Addendum No. 1
August 12, 2021

Project: DGR Engineering
Lot 4, Block 19 Dawley Farm Village Addition
2932

Architect: Architecture Incorporated

FIRST FLOOR PLAN - VENTILATION & A/C
SCALE 0 4 8 12 16

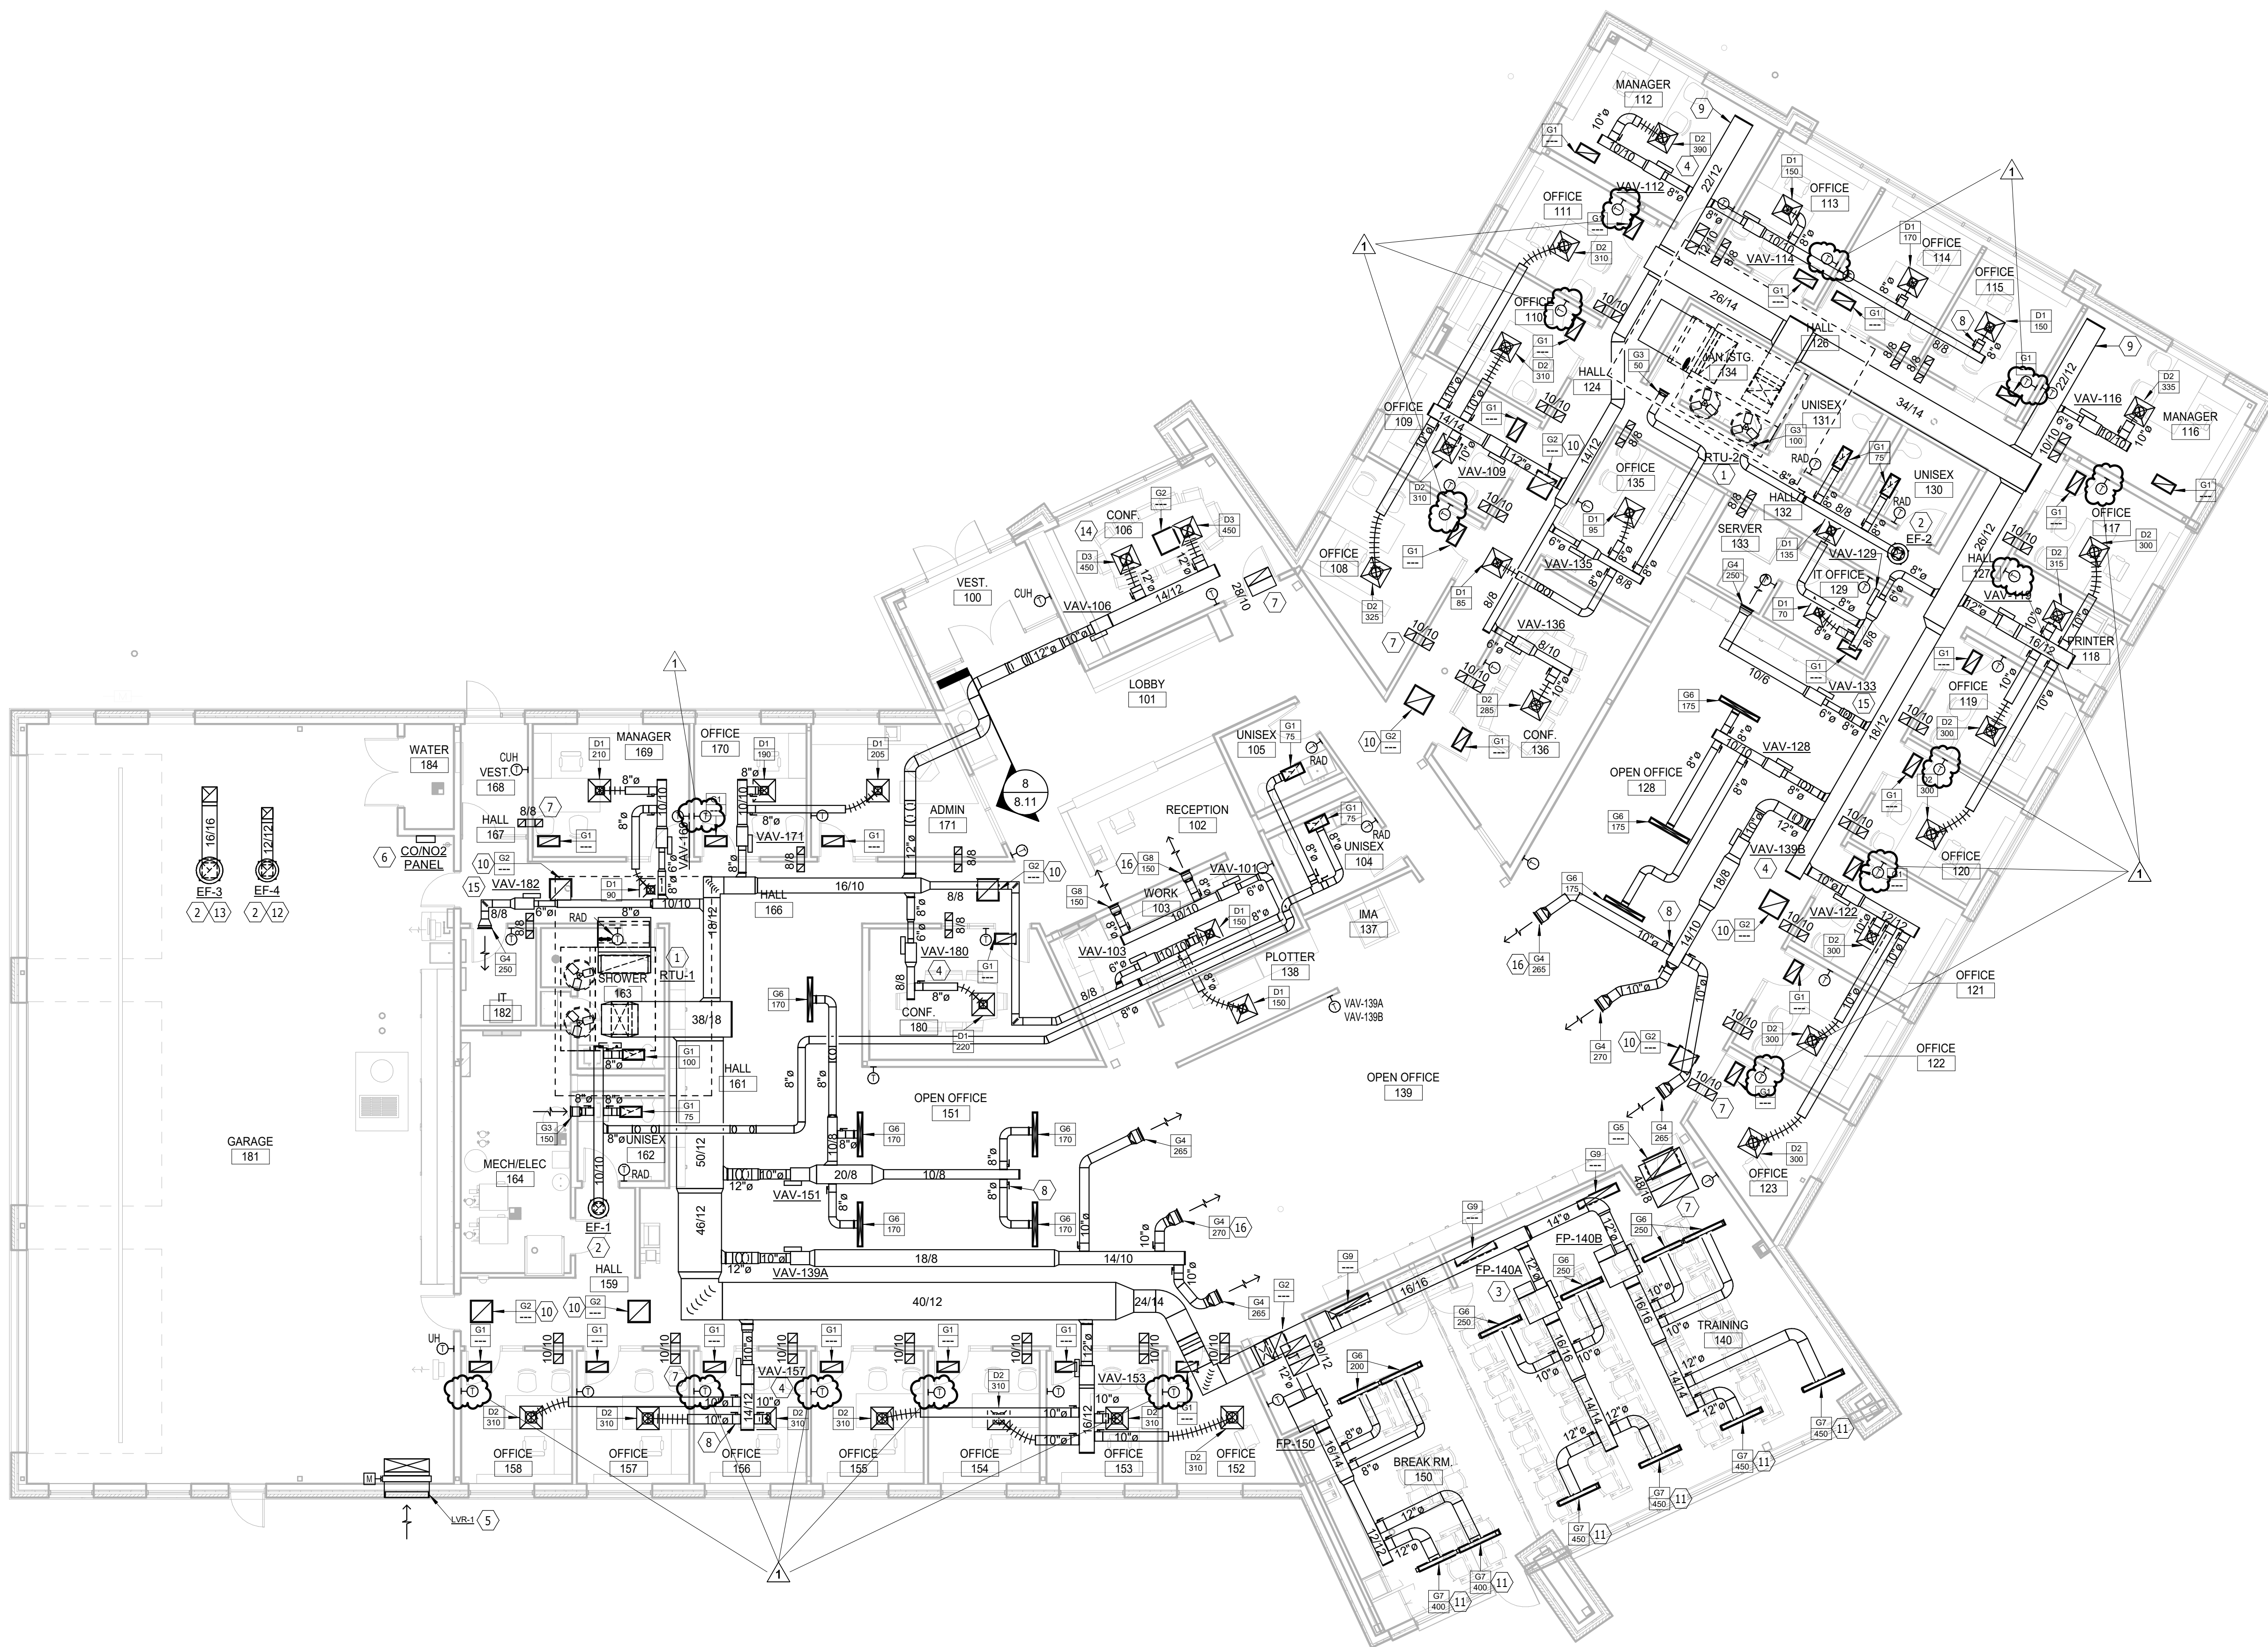
6) 8.30 – FIRST FLOOR PLAN – VENTILATION & A/C

- a) Provide thermostats for control of Radiant Ceiling Panels in the following rooms:
OFFICE 108, OFFICE 110, OFFICE 111, OFFICE 113, OFFICE 115, OFFICE 117, PRINTER
118, OFFICE 120, OFFICE 121, OFFICE 123, OFFICE 152, OFFICE 154, OFFICE 155,
OFFICE 156, OFFICE 158, OFFICE 170.

N
SCALE 0 4 8 12 16
FLOOR PLAN - LIGHTING

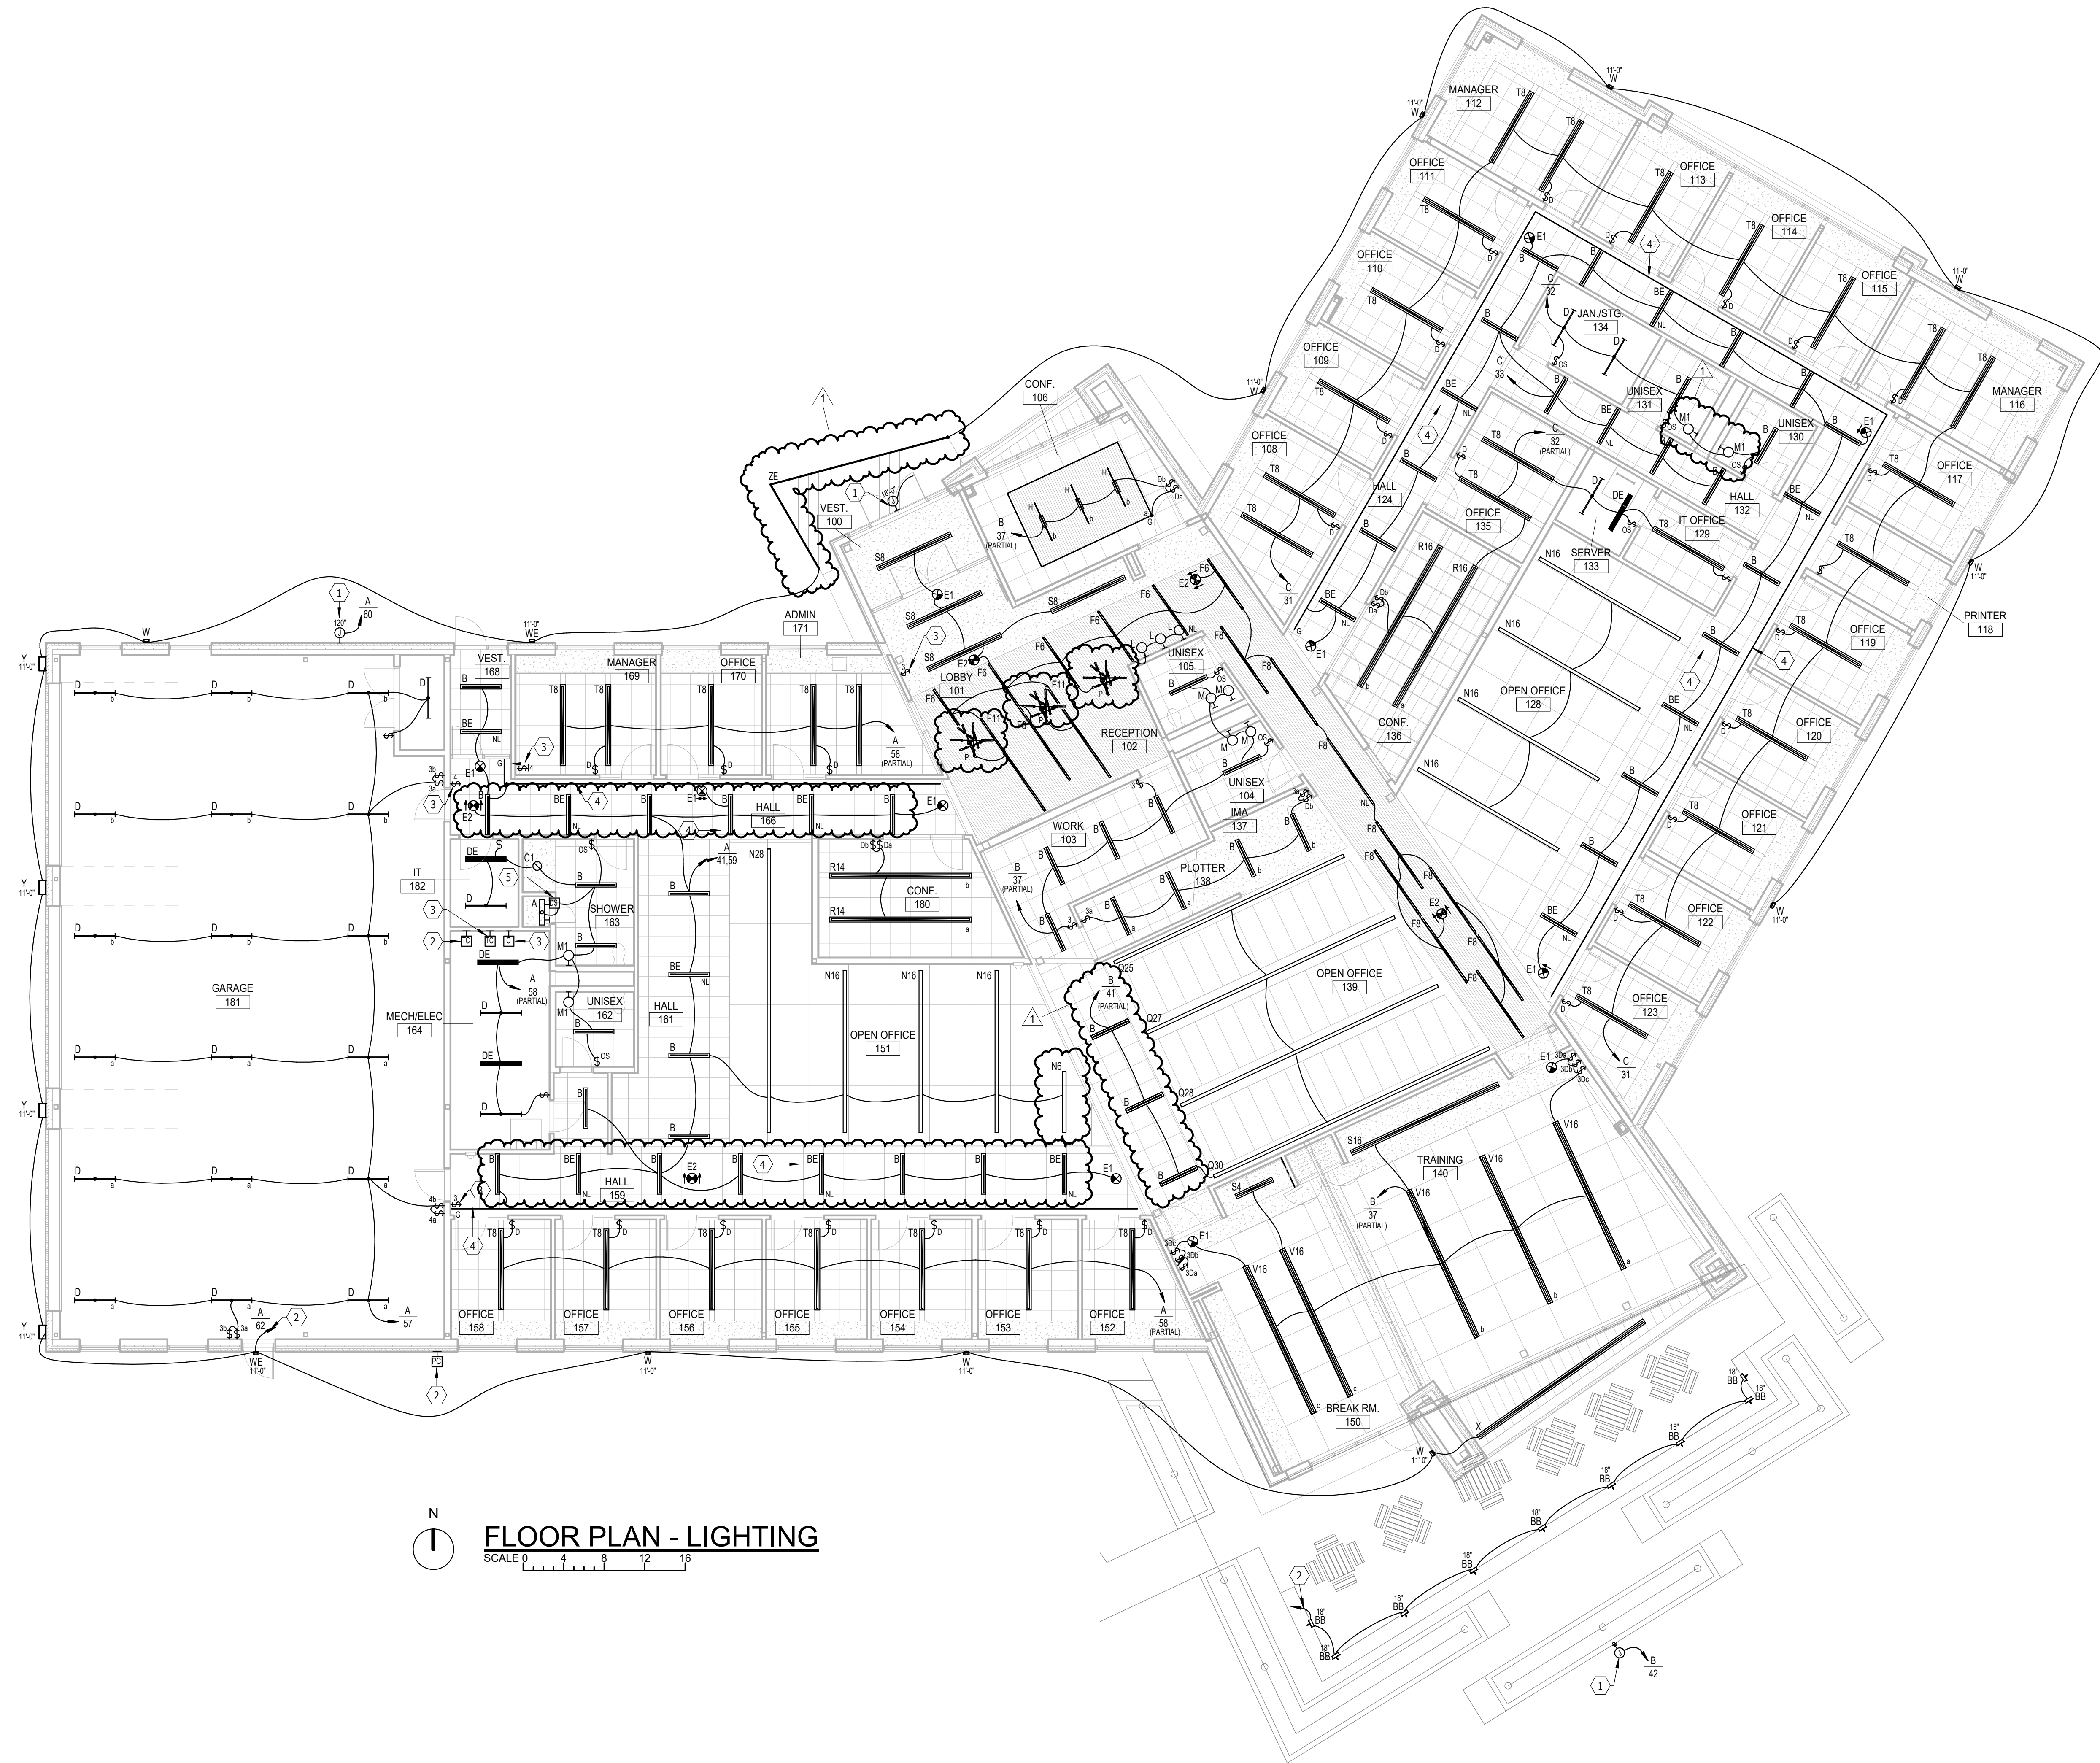
1) 9.20 – FLOOR PLAN – LIGHTING

- a) In reference to unisex restrooms 130/131, change mirror light fixture to be Type M1 in lieu of Type M. Center over top of mirror.
- b) In reference to Reception 102, mount Type P pendant lighting fixtures to be 12'-0" AFF to bottom of fixtures centered over the high part of the desk (9'-6" from the back wall) in a straight line.
- c) In reference to Open Office 151, change Type N7 to be Type N6 for reduced length of fixture from 7ft to 6ft.
- d) In reference to the front canopy, revise the exterior lighting to be Type ZE. Type ZE shall be the same as Type XE except different orientation to match the soffit/canopy construction.
- e) See attached updated lighting sheet for grid shifts associated with lighting fixture placements and other revisions listed above.

Sheet Contents **FLOOR PLAN - POWER & SIGNAL**

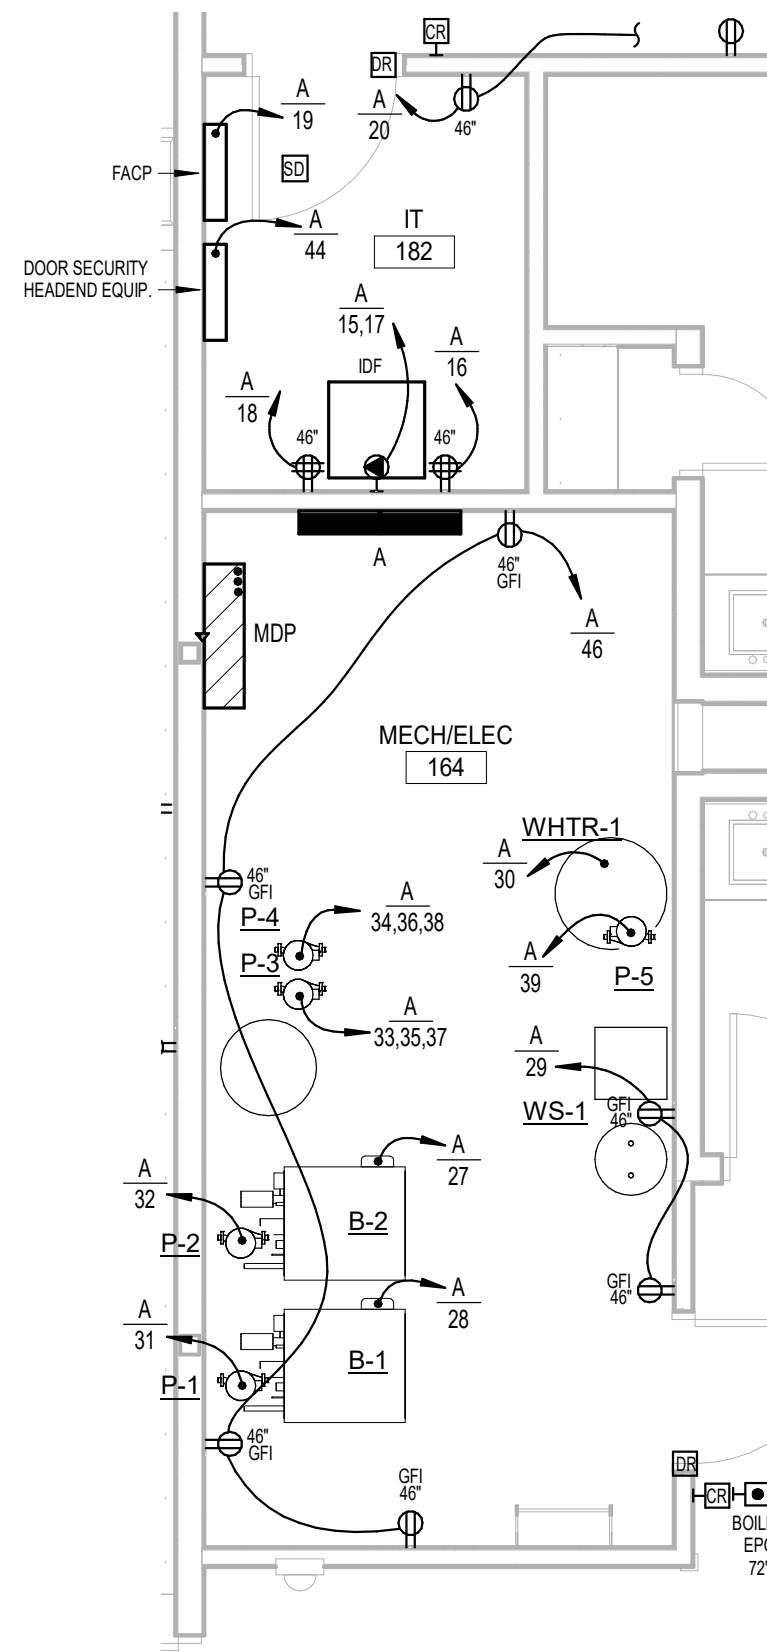
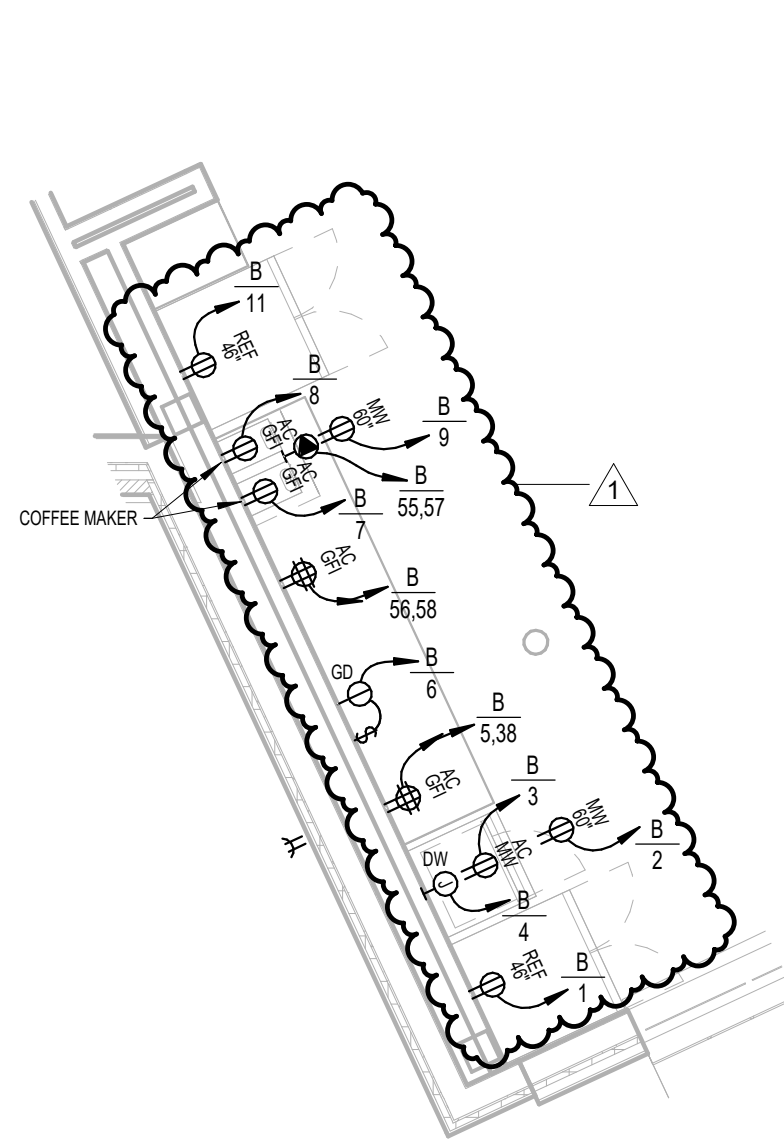
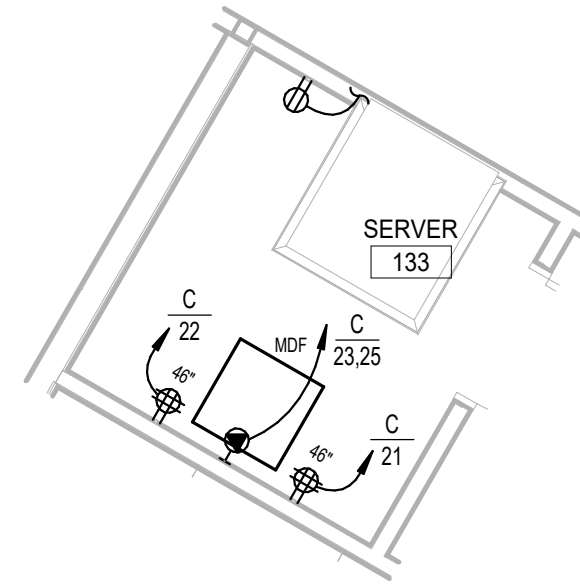
2) 9.21 – FLOOR PLAN – POWER & SIGNAL

- a) In reference to restroom groups:
 - i) 104/105: Soap dispensers changed to be battery operated. Omit undercounter receptacles keynoted #7 – no longer needed.
 - ii) Add GFCI receptacles at accessible locations within chases between restroom groups for powering cord & plug connected flush valve equipment. Typical of (3) locations as shown on the revised Drawing Sheet 9.21.
- b) In reference to Garage 181, shift CO/NO2 panel connection to north wall as shown on the attached revised Drawing Sheet 9.21.
- c) In reference to the enlarged breakroom layout, provide the following as shown on the attached revised Drawing Sheet 9.21.
 - i) Omit microwave outlet, replace with electric range outlet and circuit breaker (GFCI) in Panel B.
 - ii) Change (2) duplex above counter receptacles to be (2) quadplex receptacles each. Each duplex shall be on a dedicated circuit to serve crockpots.
